COMMUNITY DEVELOPMENT DEPARTMENT
501 Delta Avenue ♦ Marysville, WA 98270 ♦ (360) 363-8000

Re: White Barn – Chick-fil-A – *Technical Review 1*
PA23019

PRELIMINARY SITE PLAN FOR CHICK-FIL-A MARYSVILLE

C1.0

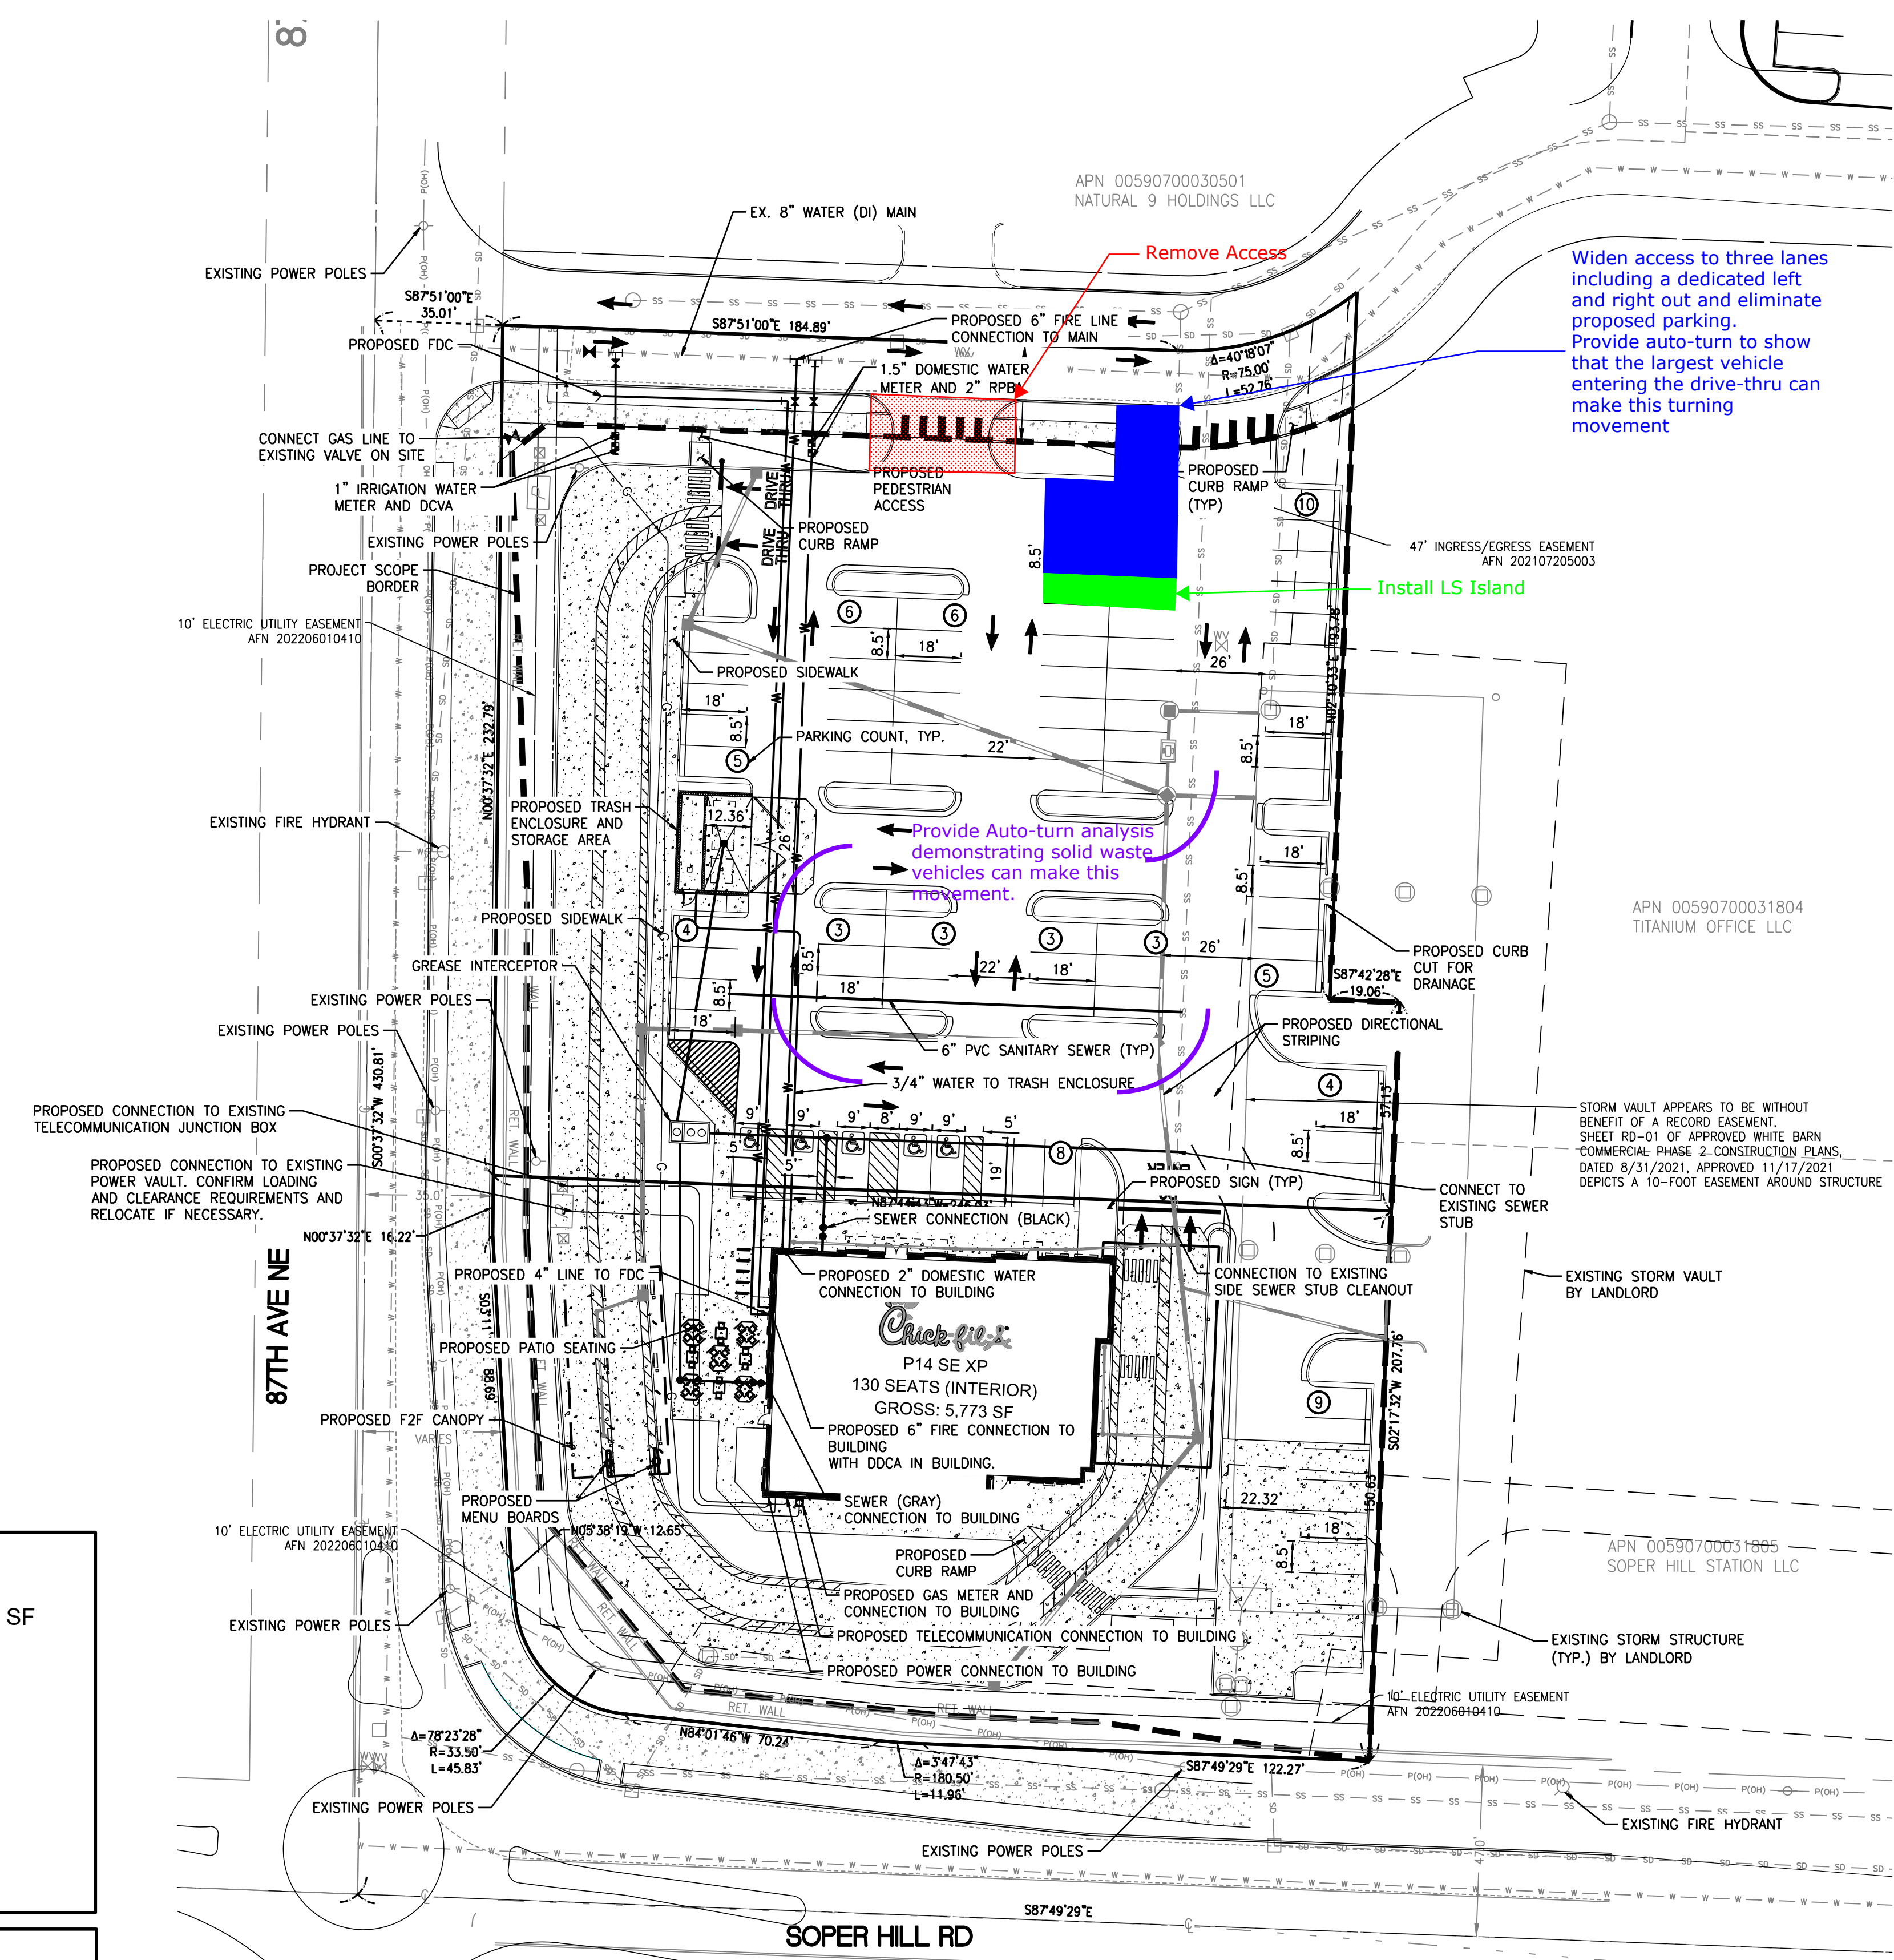
1. Provide file number PA23-019 on all future plan submittals.
2. Sheet C1.0 is too busy to review. Provide a clean version, by removing a majority of the notes and arrows, so staff can review to determine compliance with the applicable design standards and setbacks. Once a clean version is received staff will provide comments on the site plan. The following comments that were provided during pre-application review still apply:

- a. Provide the required 30' L3 buffer on Soper Hill Road and 87th Avenue NE.
 - b. Provide the required 20' L3 buffer along the eastern boundary of the property.

- c. Provide the required 15' L2 landscape buffer between Soper Hill Road and 87th Avenue NE drive-thru lanes. This can be incorporated into the required within a portion of the required 30' L3 landscape buffer.

- d. Provide the required 5' wide L2 landscape buffer between the parking areas and drive-thru. It appears a pedestrian sidewalk is proposed instead of the required landscaping.

- e. Provide a minimum 5' wide L1 landscape buffer around the proposed dumpster enclosure.
 - f. The applicant will need to ensure the size of the dumpster enclosure fits their needs. Sanitation does not provide service on Saturdays. Contact Kristy Beedle, Sanitation Supervisor, phone: 360.363.8152 email: kbeedle@marysvillewa.gov, for additional information.

- g. No more than 50 percent of the 87th Avenue NE frontage may be occupied by vehicular access or parking.

- h. Provide auto-turn from the north private drive demonstrating the largest vehicles using the drive-thru have adequate turning radius to enter into the drive-thru. The drive-thru appears rather close to the east-west private drive in order to make this turn. Suggested changes included on attached red lined site plan.

- i. Both motor vehicle and pedestrian cross access will be required from the Soper Hill Station to Chick-fil-A. Provide the pedestrian connection.
 - j. The pedestrian crossings along the north entrance shall be constructed with decorative concrete, similar to what has been installed on the White Barn development site. This detail will need to be provided.
